**Subject: Follow up Comments to the ENERGY STAR Draft 2 Version 7.0 Proposal**

On behalf of the Northwest Energy Efficiency Alliance (NEEA) and Sacramento Municipal Utility District (SMUD), we respectfully submit comments in regards to the ENERGY STAR Draft 2 Version 7.0 Television specification issued September 2<sup>nd</sup>, 2014.

**Figure 1: US Market Penetration of Ultra High Definition Televisions, 2012-14**<sup>1</sup>

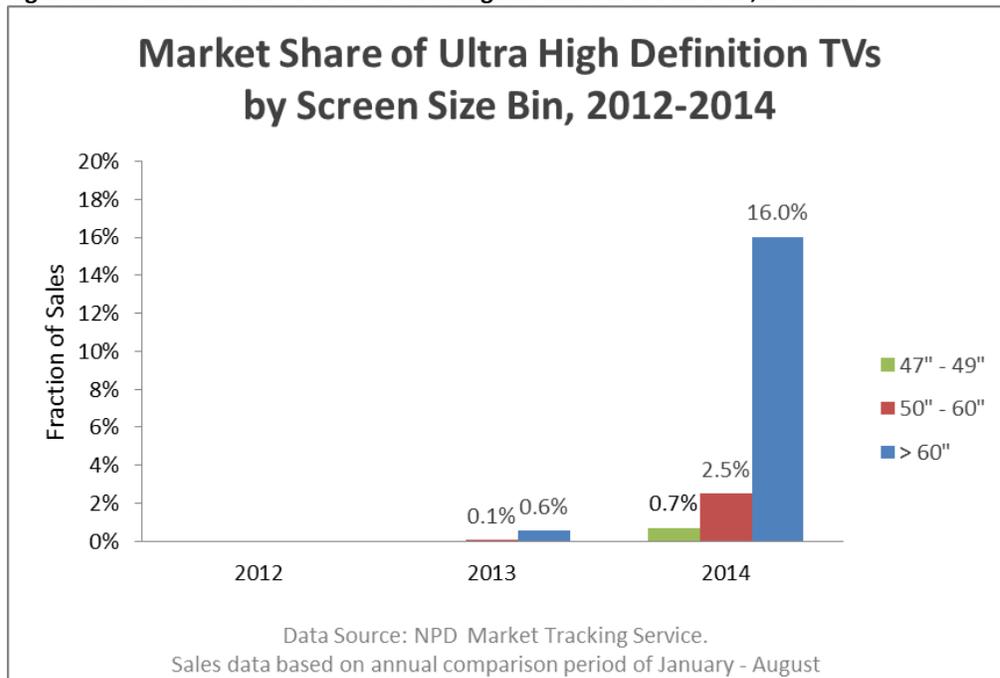
Ultra High Definition (UHD) televisions consume substantially more energy than HD TVs when displaying standard HD content. Although UHD TVs represent only 1.2% of total US TV sales, they are expected to achieve rapid growth in the next few years, particularly for larger screen sizes. Within the >60" TV size bin, UHD market penetration increased by over 25 times in the past year from 0.6% in 2013 to 16.0% in 2014. Similarly, TVs within the 50-60" size bin made substantial gains in 2014.

**Figure 2: Ultra High Definition TVs: On Mode Power when displaying HD content**

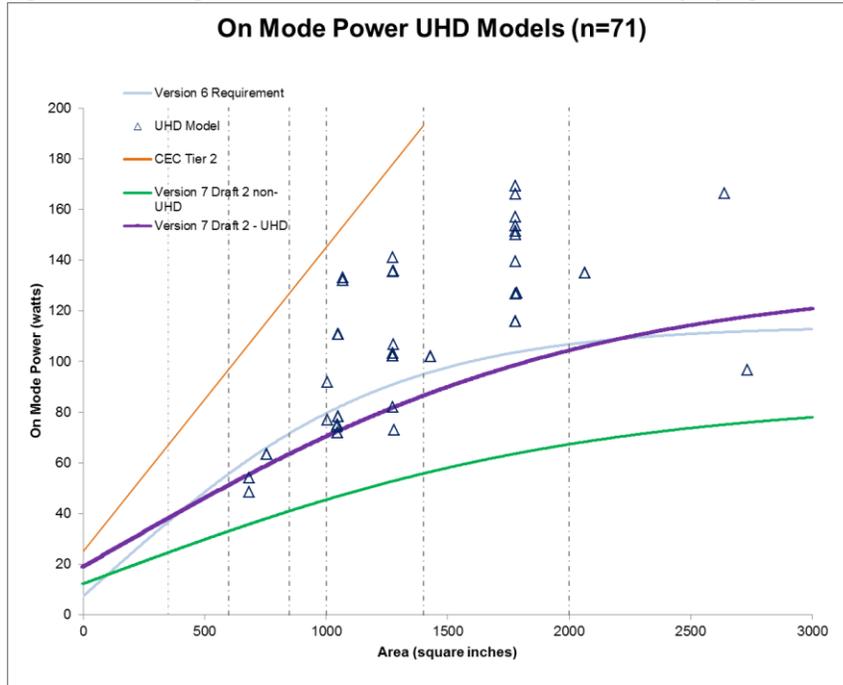
As UHD technology costs continue to decline, we expect to see cascading effects and greater UHD adoption in smaller TV sizes. While UHD content is not yet readily available, most of these UHD TVs improve picture quality by ‘upconverting’ existing HD content to UHD through a process of pixel interpolation.<sup>2</sup> We analyzed on mode data of UHD TVs from CEC’s Appliance Database (60 models) and from ENERGY STAR’s Qualified Products List (11 models) and found a number of models that already meet the Draft 2 proposal with the extra UHD power allowance (see Figure 2).

While the UHD market is growing rapidly, it still reflects a very small fraction of the market. We believe the 55% adder provides a sufficient incentive for manufacturers to reduce UHD energy consumption. Because reducing UHD energy consumption is an iterative process, we support the gradual decrease in the UHD adder instead of its abrupt expiration in 2017. Therefore, we suggest that EPA include language to reassess the adder in mid-2016, with a revised adder taking effect in March 2017 when the 2017 models become available.

Figure 3. Standby Active Low Mode (note logarithmic scale)

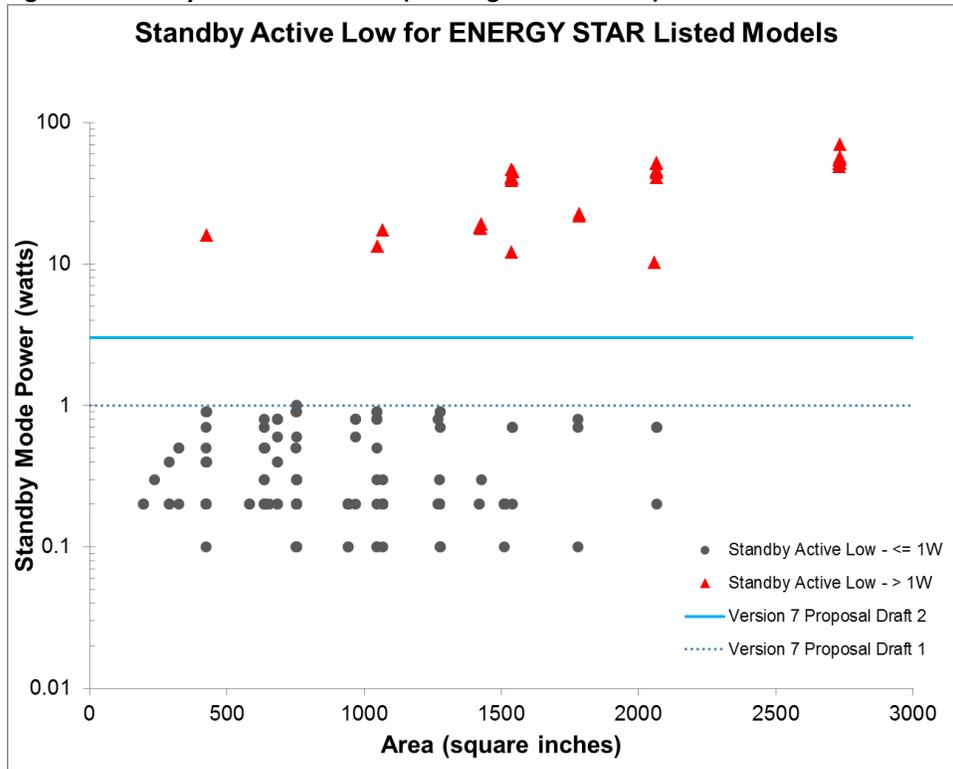
Over 30% of all TVs (and roughly half of TVs 40” or greater) now have network connectivity capabilities. In this case, the TVs are no longer simply “off” (i.e., standby passive mode) when the TV is not displaying an image, but are connected in varying degrees to a network and consuming significantly more power than in standby passive mode. Based on the current ENERGY STAR QPL, there still remains a wide variation of reported power for those models with standby active low mode (see Figure 3). However, it is still unclear why this is the case, although it is suspected that this is due to the Quickstart function being enabled. Of the 241 models with reported standby active low mode values, 41 models (all from two manufacturers) have reported values of 10 watts or above (see Figure 3). The remaining 200 models had reported values 1 watt or below (including Smart TVs from these same two manufacturers).

This wide variation in the reported values for Standby Active Low suggests that there are testing discrepancies or additional power consuming activities in the background for those models with high reported values. We encourage EPA and DOE to identify and correct any testing discrepancies to ensure the data used in developing standby active low mode requirements is not corrupted, as suggested by some stakeholders.

**Figure 4: CEC TVs: Standby Passive Mode**

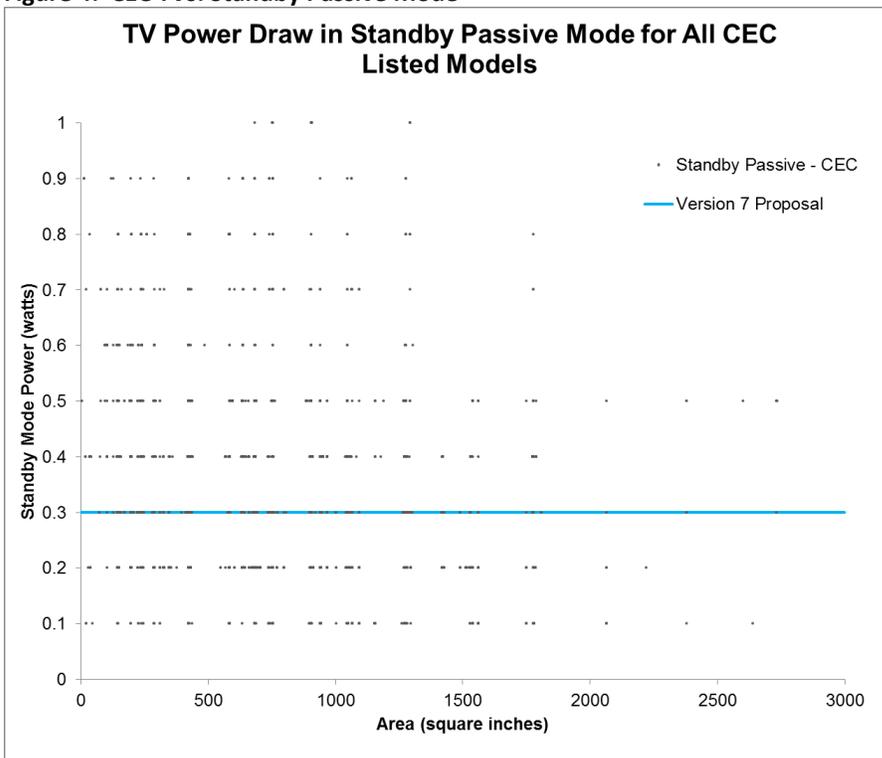
Based on our analysis of the updated CEC appliance database, over 65% of TV models in the CEC database meet EPA’s proposed standby passive mode requirement of 0.3 Watts (see Figure 4). We support these more stringent requirements for Standby passive mode.
